KEWAUNEE NUCLEAR POWER PLANT

AMENDMENT TO FACILITY OPERATING LICENSE

Amendment No. 19
License No. DPR-43

SUPPORTING AMENDMENT NO. 19 TO FACILITY LICENSE NO. DPR-43

FUNCTIONAL ORGANIZATION
 POWER SUPPLY AND ENGINEERING DEPARTMENT
 WISCONSIN PUBLIC SERVICE CORPORATION

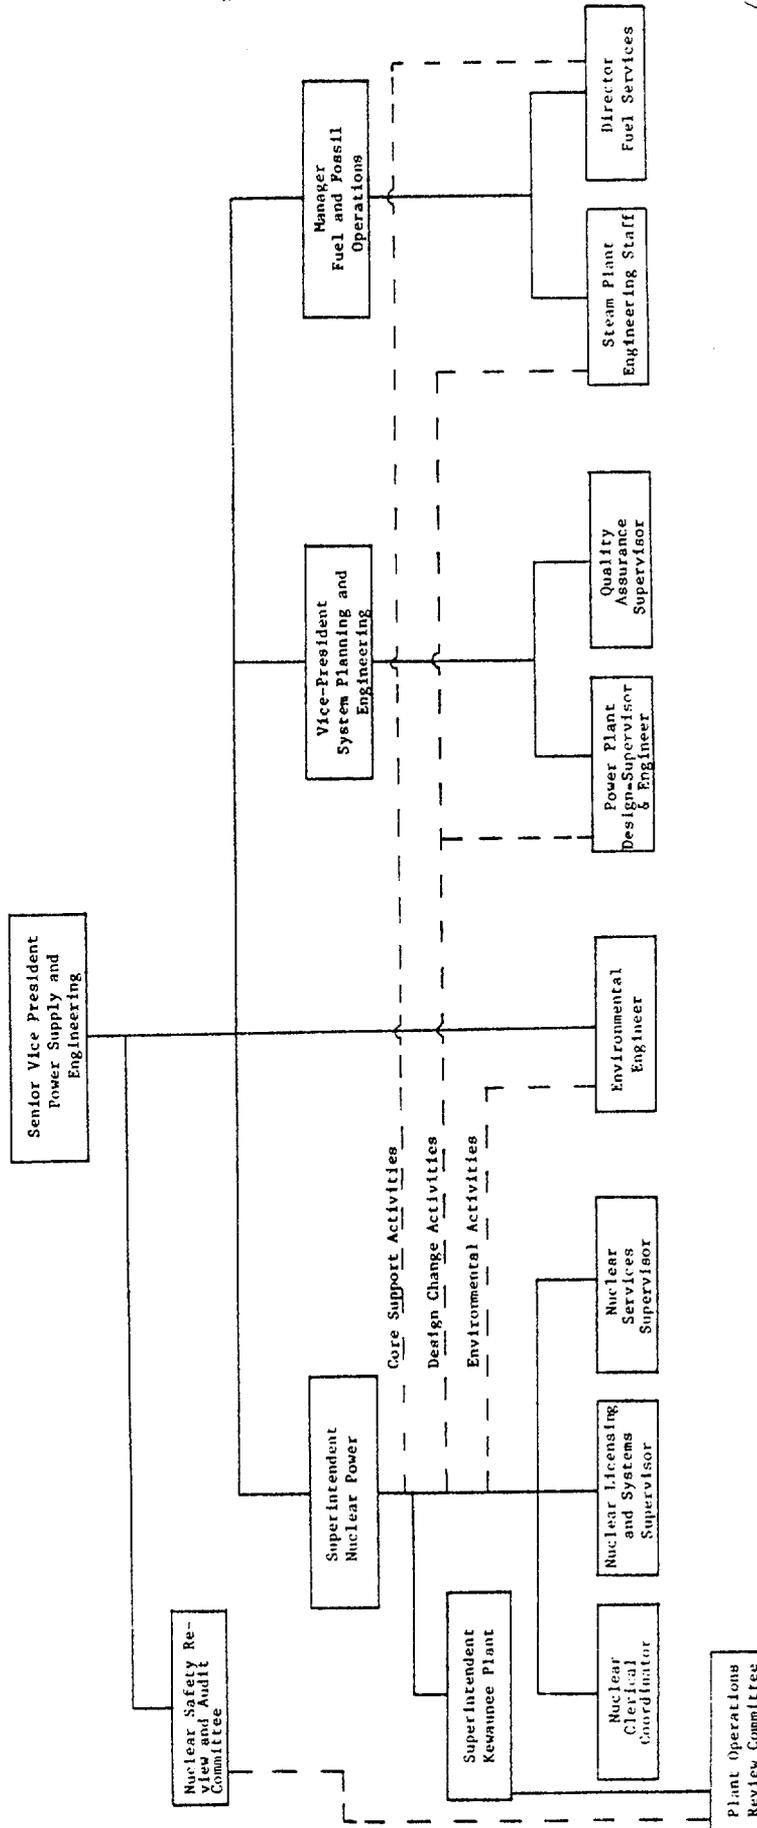
The organizational charts for the corporate nuclear staff of Wisconsin Public Service and the Kewaunee Plant would show the revised corporate reporting structure and additional personnel involved in the nuclear organization.

We have reviewed this proposed change and find it to be administrative and without adverse affect on the responsibility and authority of the organizational personnel involved. We find this change to be acceptable.
